**STATE OF VERMONT
PUBLIC UTILITIES COMMISSION**

Amended Petition of Deerfield Wind, LLC, for a certificate of public good authorizing it to construct and operate a 15-turbine, 30 MW wind generation facility, and associated transmission and interconnection facilities, on approximately 80 acres in the Green Mountain National Forest, located in Searsburg and Readsboro, Vermont, with 7 turbines on the east side of Route 8 on the same ridgeline as the existing GMP Searsburg wind facility (Eastern Project Area), and 8 turbines along the ridgeline to the west of Route 8 in the northwesterly orientation (Western Project Area)	PUC Docket N. 7250
---	--------------------

**WINDACTION-SHEA JOINT COMMENTS IN RESPONSE TO
VERMONT PUC ORDER OF FEBRUARY 12, 2020**

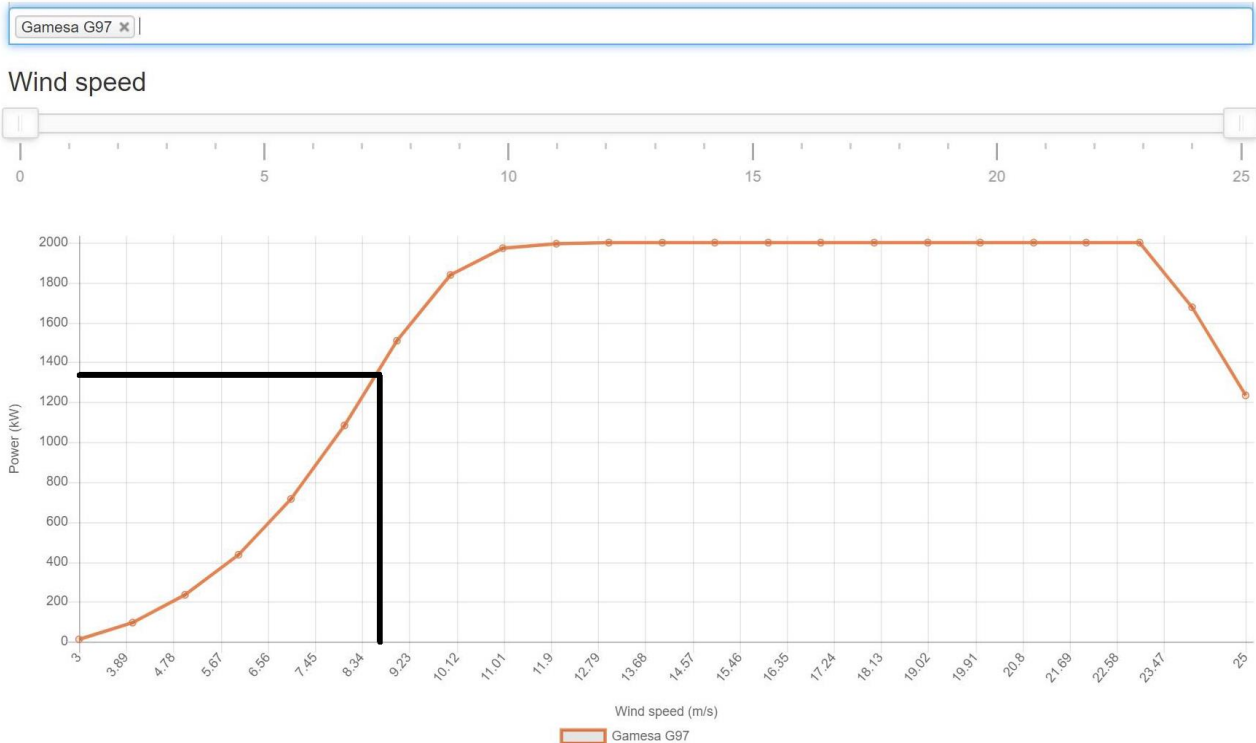
Mr. Kaliski’s figures further confirm that the Department’s strict adherence to the 6 m/s threshold is incorrect. The manufacturer’s power curve for the Gamesa G97 turbines (below) shows the G97 does not achieve 67% of full electric output (1,350± kW) until hub height wind speeds reach nearly 9 m/s.
